EPC STORMWATER REVIEW COMMENTS
IN ORANGE BOXES WITH BLACK TEXT

Drainage Letter

The Landings of Denmark

PCD Proj No.: CDR-22-012

61108 - Byrd Ct 2-24 inch RCP Class III w/ FES (100-yr)

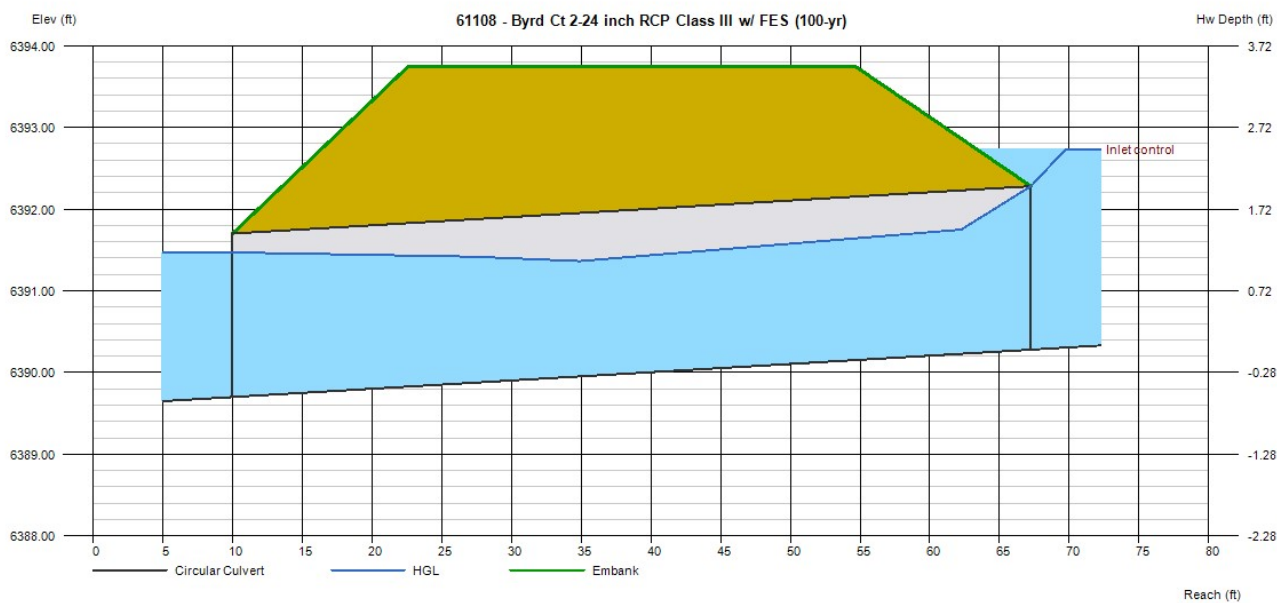
Provide calculations for riprap outlet protection. (Type, length, width, etc)

61108-Byrd Ct Trap Channel - 100 yr

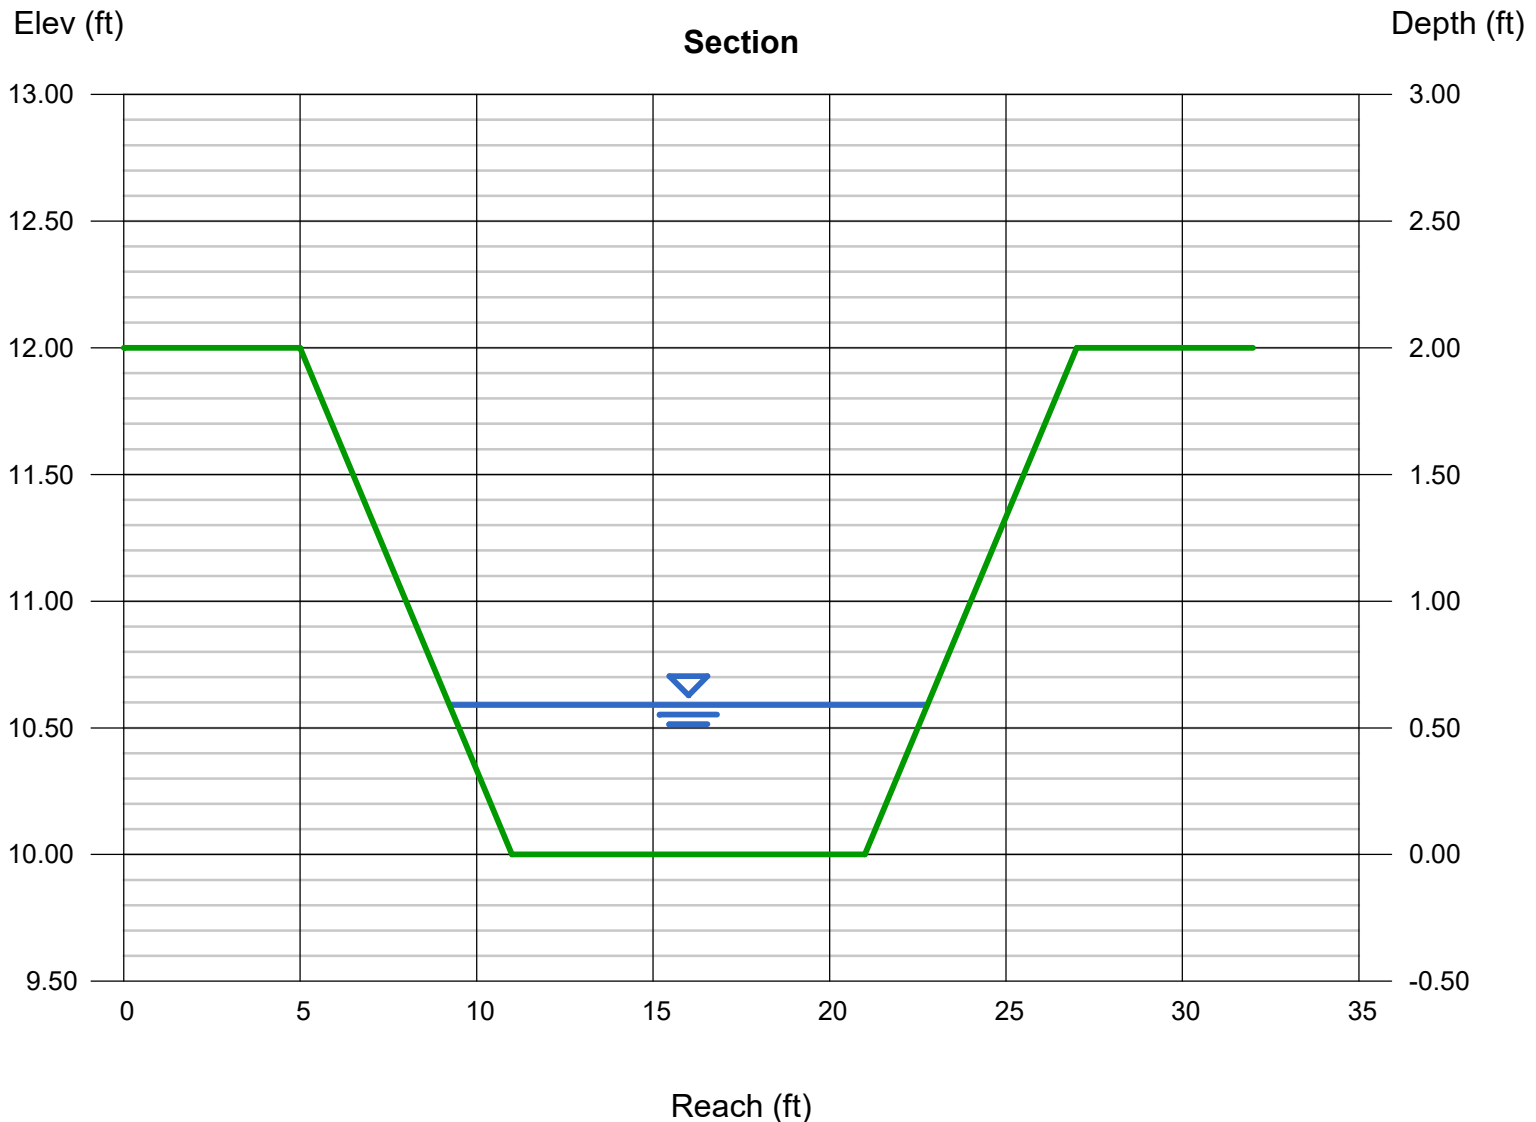
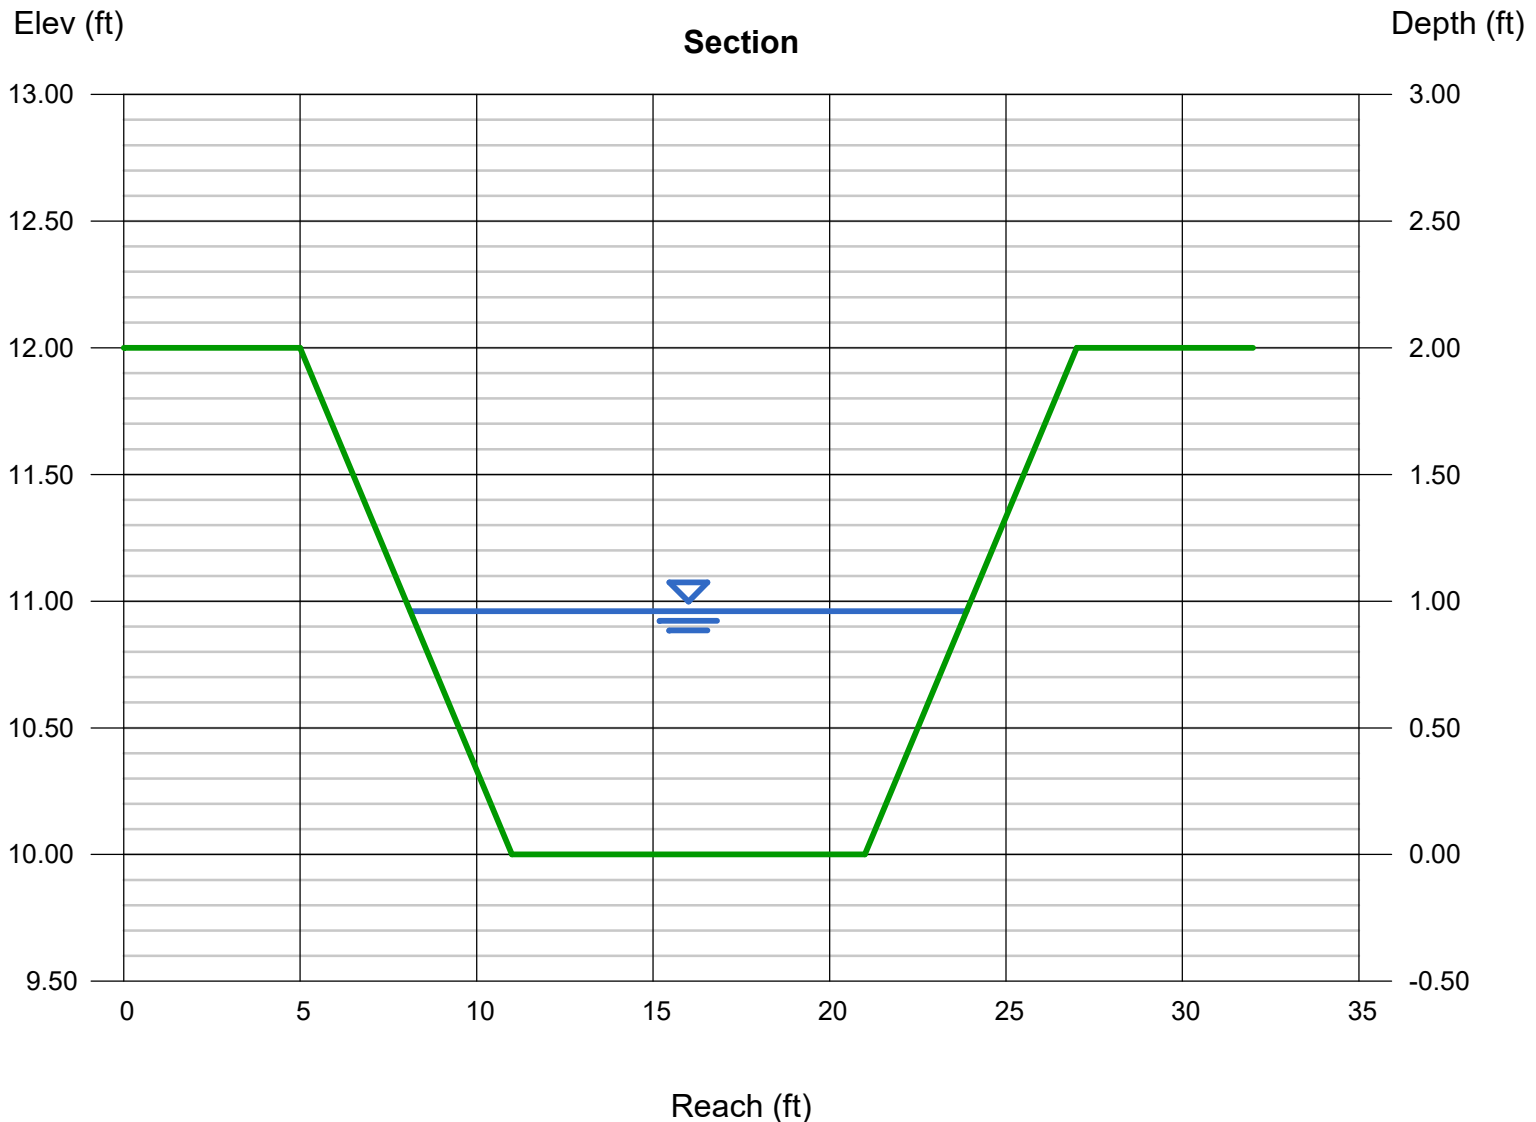
Indicate if this is for drainage channel or roadside ditch. Please provide additional calculation for whichever one this is not.

61108 - O'Steen Ct: 2-24 inch Class III RCP w/ FES (100 yr)

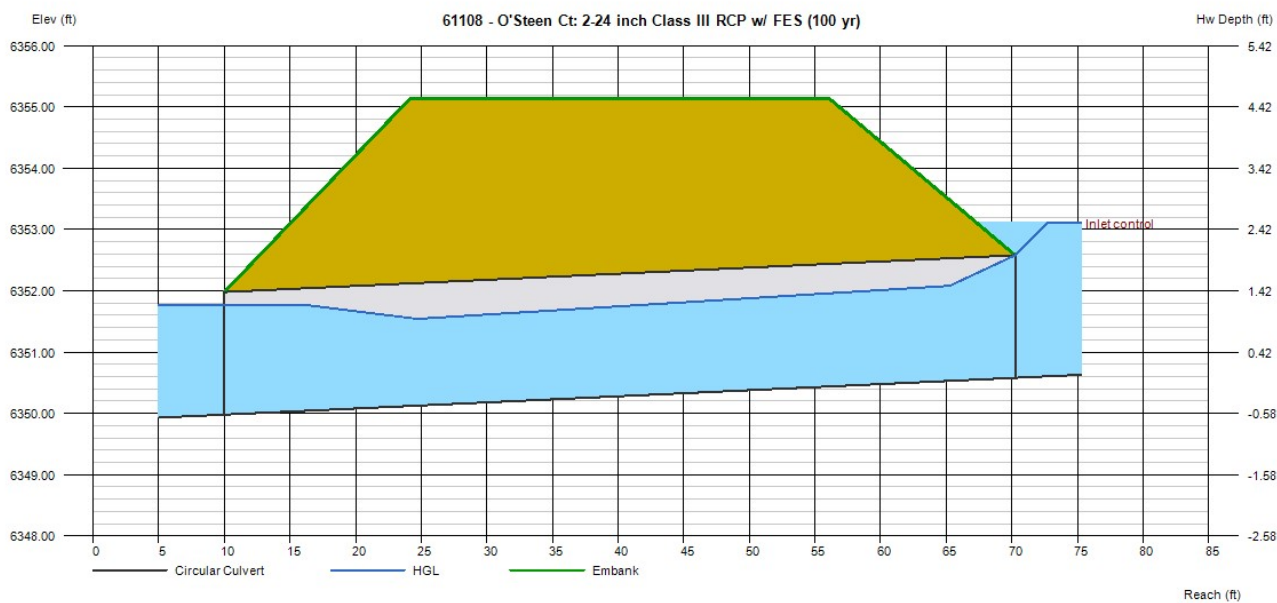
Provide calculations for riprap outlet protection. (Type, length, width, etc)

61108-O'Steen Ct 10 Bottom Width Transition to 8' Bottom Width Trap Channel-100yr

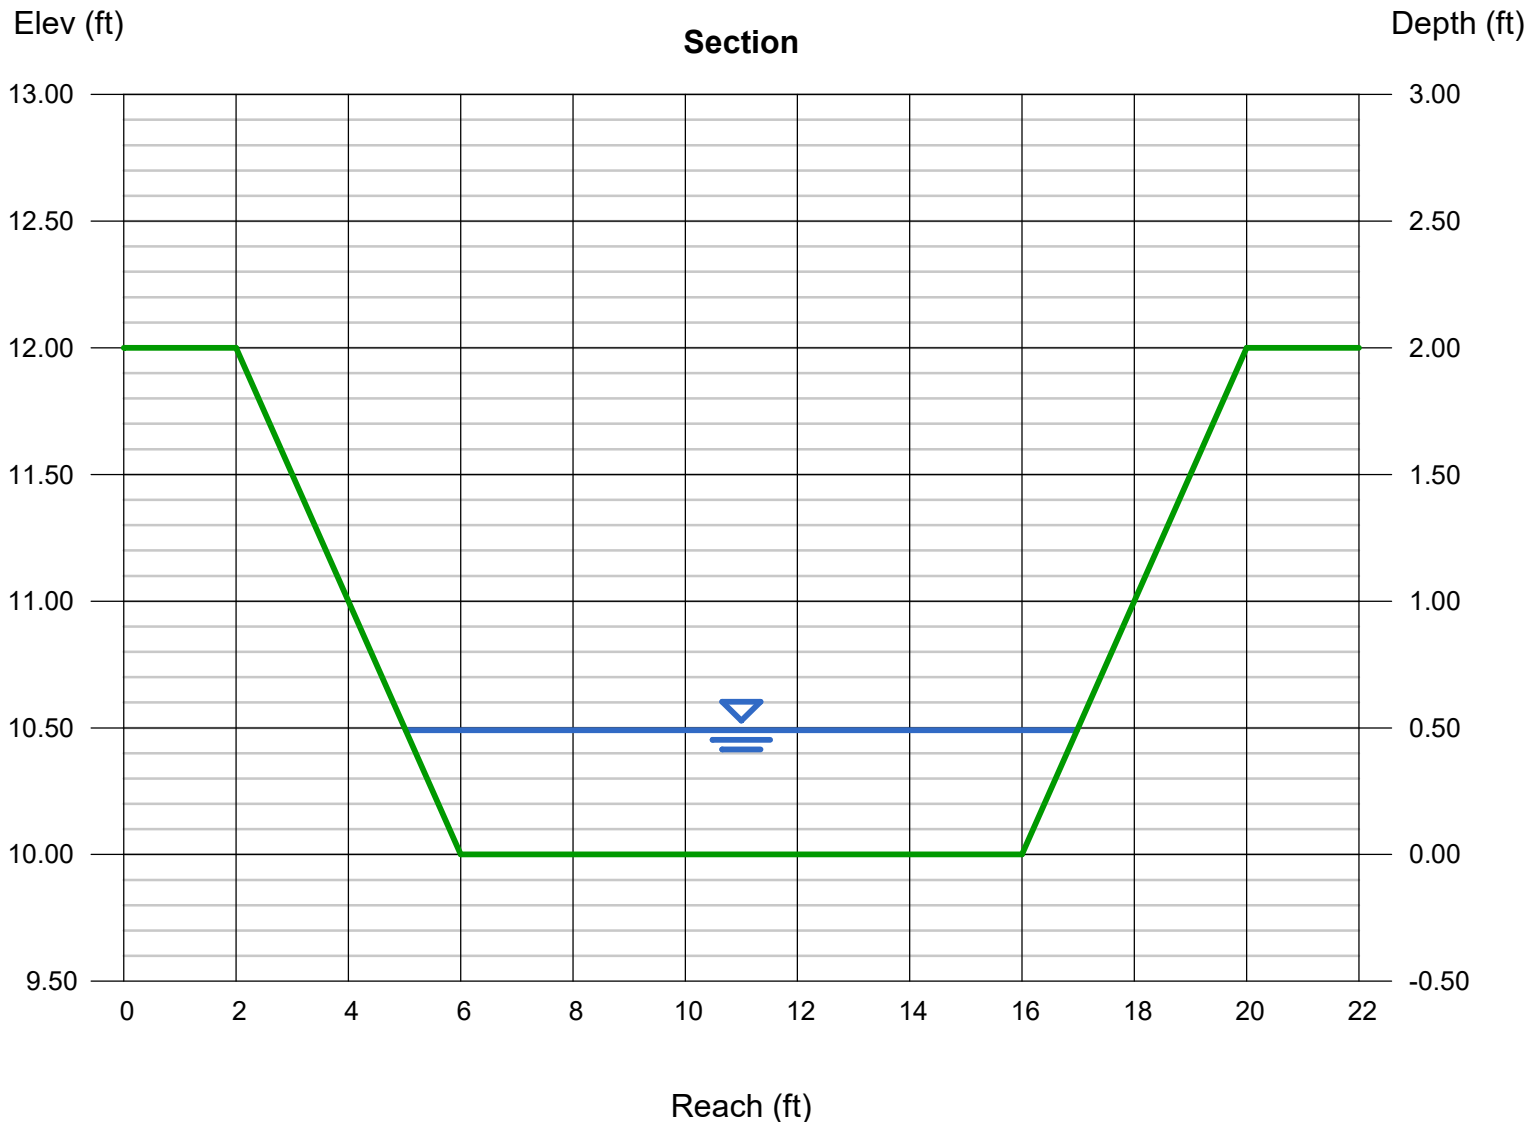
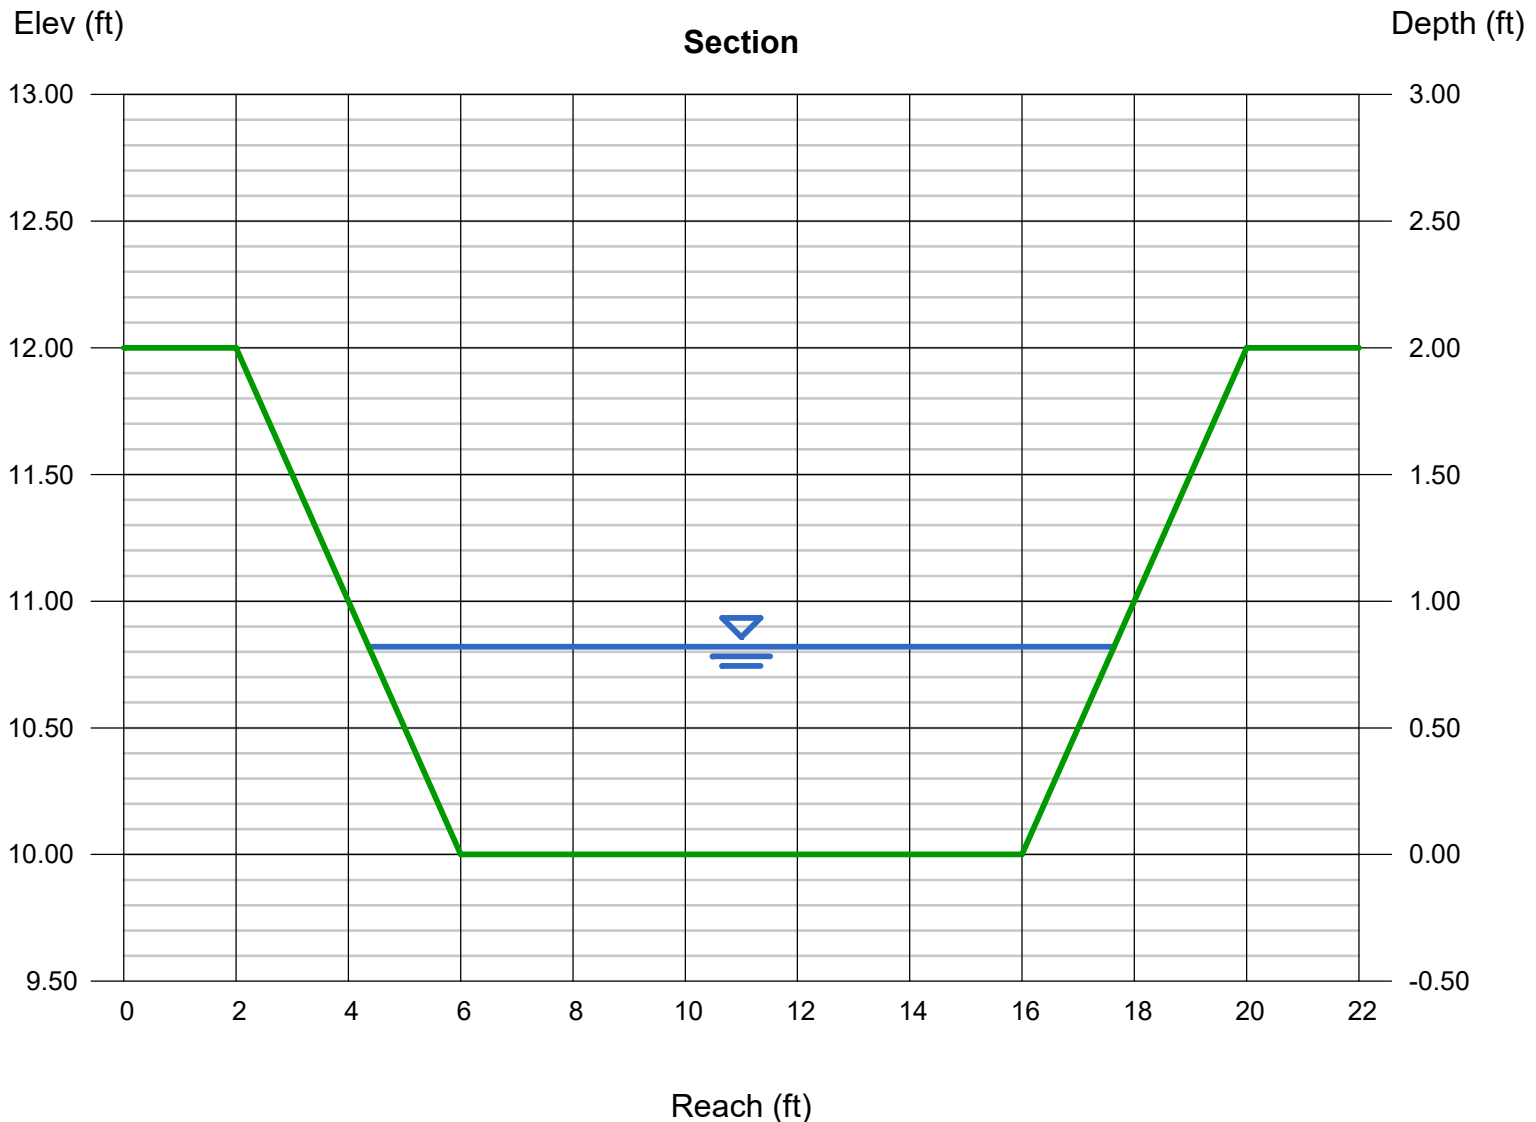
Indicate if this is for drainage channel or roadside ditch. Please provide additional calculation for whichever one this is not.
